Response to the Reviewers' Comments

The authors would like to thank the reviewers for the precious comments and suggestions on the technical contents and presentation of our manuscript “Runtime Power Management of Battery Electric Vehicles for Extended Range with Consideration of Driving Time,” submitted to IEEE Transactions on Very Large Scale Integration (TVLSI.) This revised manuscript has been greatly improved thanks to the reviewers’ invaluable advices. We have revised the manuscript faithfully following the reviewers’s comments. We include the newly added or significantly modified parts in the revised version of the paper also in Response to Reviewers. We highlight the important technical content changes and set those parts in a red color in the revised paper.

Fig. 2: (a) Range-speed experimental data for Chevrolet Bolt [36] and (b) comparison with simulation results of the proposed EV power model.

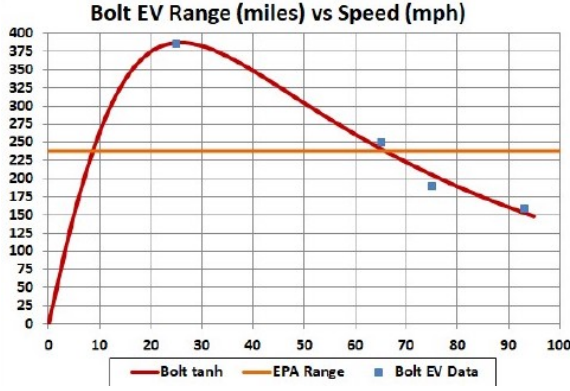
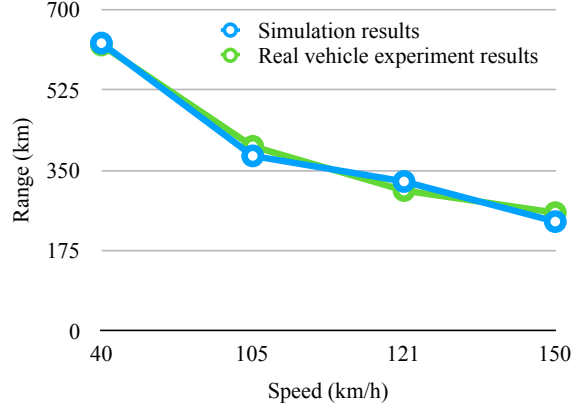
R1-C2 It is not clear how to validate the power model of EV. As the author mentions that accuracy of power model is quite important, it is good to see the power model in this paper can be validated by some real measurement results.

We further evaluate the model accuracy with the range-speed real vehicle experiments as shown in Fig. 2(a) to confirm the derived power models are close enough to the real vehicle measurement data [32], [33], [34], [35], [36]. We refine the coefficients until all the available data values match well.

As a result, the derived EV power model well matches with the range-speed experimental data as shown in Fig. 2(b) as well as the top speed and maximum acceleration setting the aerodynamic resistance, rolling resistance, curb weight, etc. with the known values. The errors in the range-speed simulation is merely 1.4%, the time for 0-to-100 km/h error is 7.8%, and the top speed error is 3.0%, respectively.

Fig. 12: Velocity profile comparison with EDP , E^2DP and E^3DP on Jones Street in San Francisco.

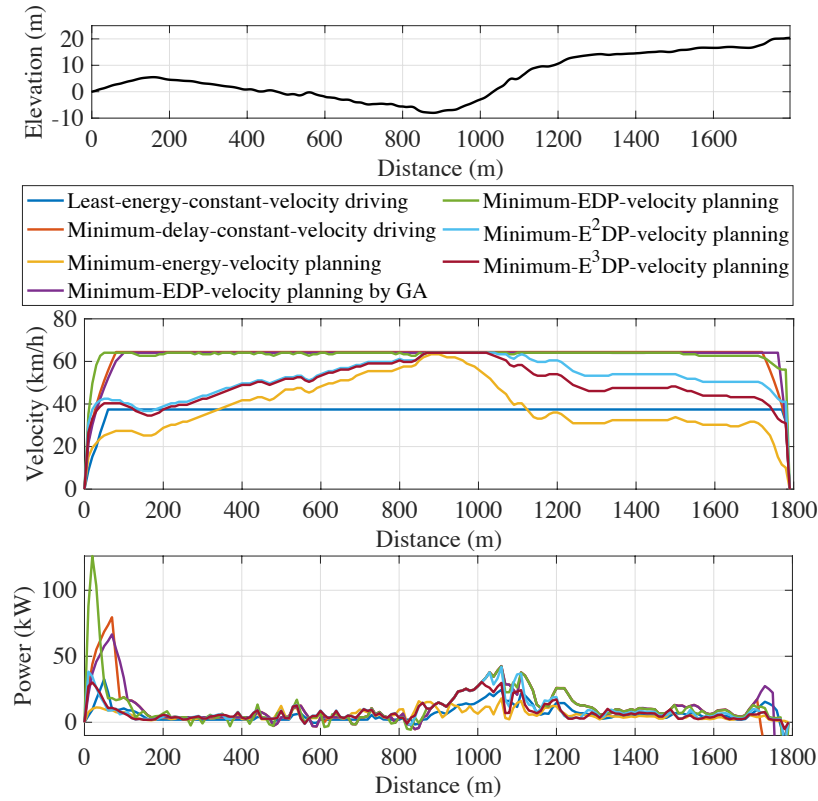
R1-C3 The optimality of the proposed scheduling algorithm is unclear. The author should add several paragraphs to discuss this topic. It is also to see the comparison baseline is well accepted to show the advantage of the proposed algorithm.

We also updated Fig. 12 and Fig. 13:

Fig. 11: Histograms of velocity and acceleration for the proposed energy-aware-velocity planning methods without an acceleration constraint (a) and (b) and with an acceleration constraint (c) and (d), respectively.

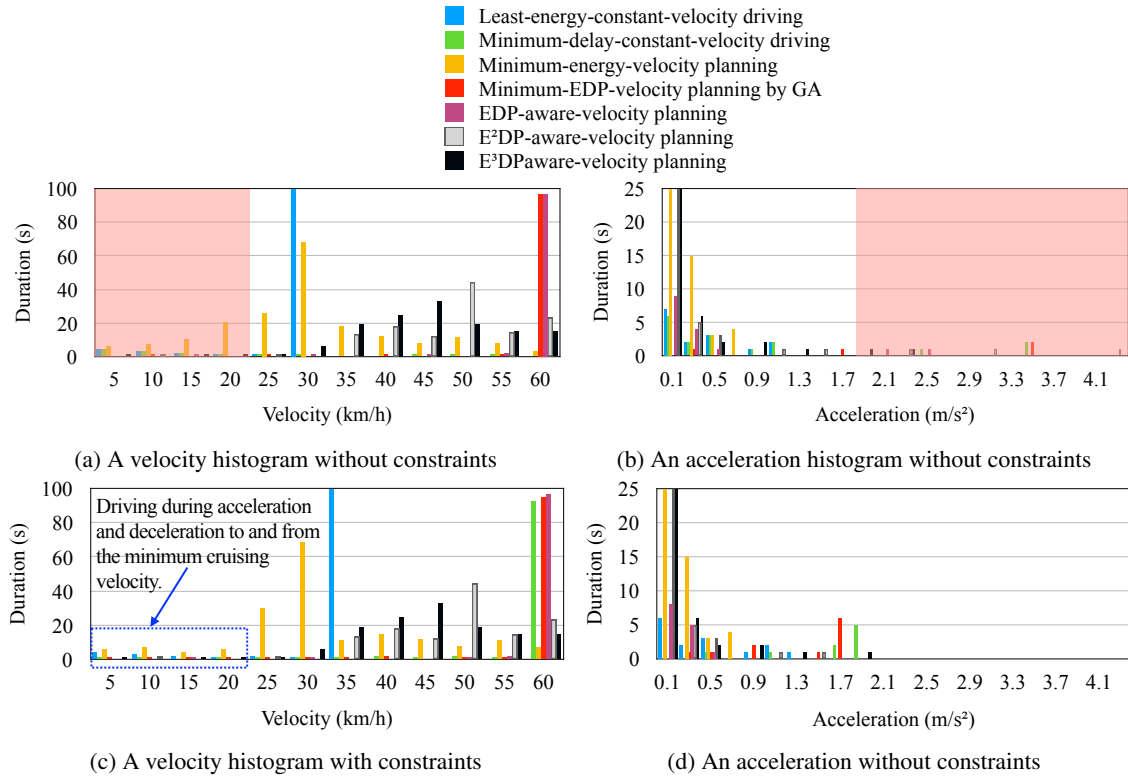
R2-C2 It would be good to have more discussion on the assumptions of the approach and the experiments, e.g., how much can the velocity be changed in practical scenarios without impeding traffic and causing unsafe situations (also depending on the road conditions and whether it is urban or rural environment I suppose). Currently, there only seems to be one constraint on not slower than 10 km/h.

Fig. 11(a) and (b) show two histograms of the driving schemes in Fig. 12, which do not have velocity and acceleration constraints. We avoid a cruising velocity lower than 25 km/h and an acceleration higher than 2.0 m/s^2 in this paper without loss of generality. The acceleration of 2.0 m/s^2 is the same as the maximum acceleration of compact cars designed to be used primarily used in urban areas (13 seconds of 0 to 100 km/h time).

Fig. 11(c) and (d) shows the velocity and acceleration histograms with the constraints. Once we run the DP for the first time without constraints, we analyze the histogram, adaptively determine the minimum cruising velocity and maximum acceleration constraints, and run DP again. We keep the same constraints for online recomputation whenever unexpected interrupts occurs.

acceleration for the proposed energy-aware-velocity planning methods. Fig. 11(a) and (b) show two histograms of the driving schemes in Fig. 12, which do not have velocity and acceleration constraints. We avoid a cruising velocity lower than 25 km/h and an acceleration higher than 2.0 m/s^2 in this paper without loss of generality. The acceleration of 2.0 m/s^2 is the same as the maximum acceleration of compact cars designed to be used primarily used in urban areas (13 seconds of 0 to 100 km/h time).

Fig. 11(c) and (d) shows the velocity and acceleration histograms with the constraints. Once we run the DP for the first time without constraints, we analyze the histogram, adaptively determine the minimum cruising velocity and maximum acceleration constraints, and run DP again. We keep the same constraints for online recomputation whenever unexpected interrupts occurs.

Fig. 8: Benchmark altitude.

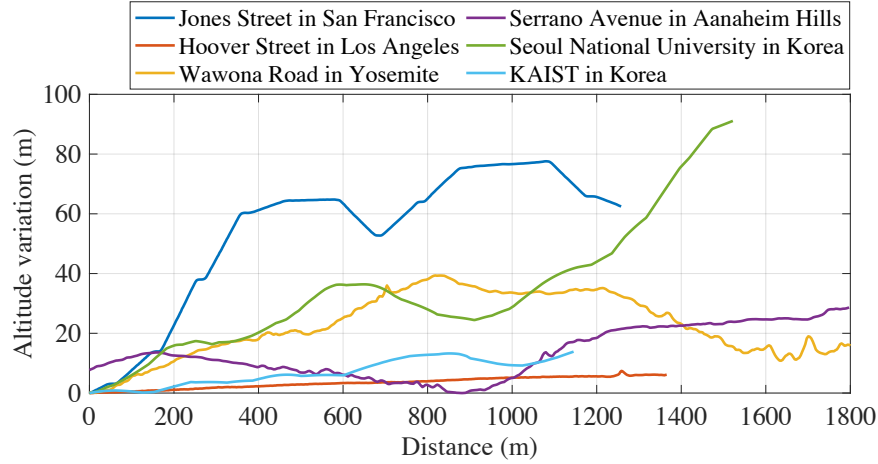
R2-C3 Related to the last point, it would be good to have more discussion on the road benchmarks, e.g., how they are generated and how representative they are. The optimization results significantly depend on road slope. It would be good to use a variety of real road segments for testing.

R2-A3 We appreciate the reviewer's comment and added six new real routes from various locations in California. The first three roads are in cities. Jones Street in San Francisco and Hoover Street in Los Angeles are two representative city landscapes such as hills and flat roads, respectively, and Cliff Drive in Santa Barbara is a mixture of those. The second two roads are in mountain areas: Serrano Avenue in Anaheim Hills and Otay Lakes Road in San Ysidro Mountain in California. The last road is Junipero Serra Boulevard connecting San Francisco and San Jose. The details of road data is summarized in Table II, and Fig. 8, which visualize the altitudes of the road benchmarks.
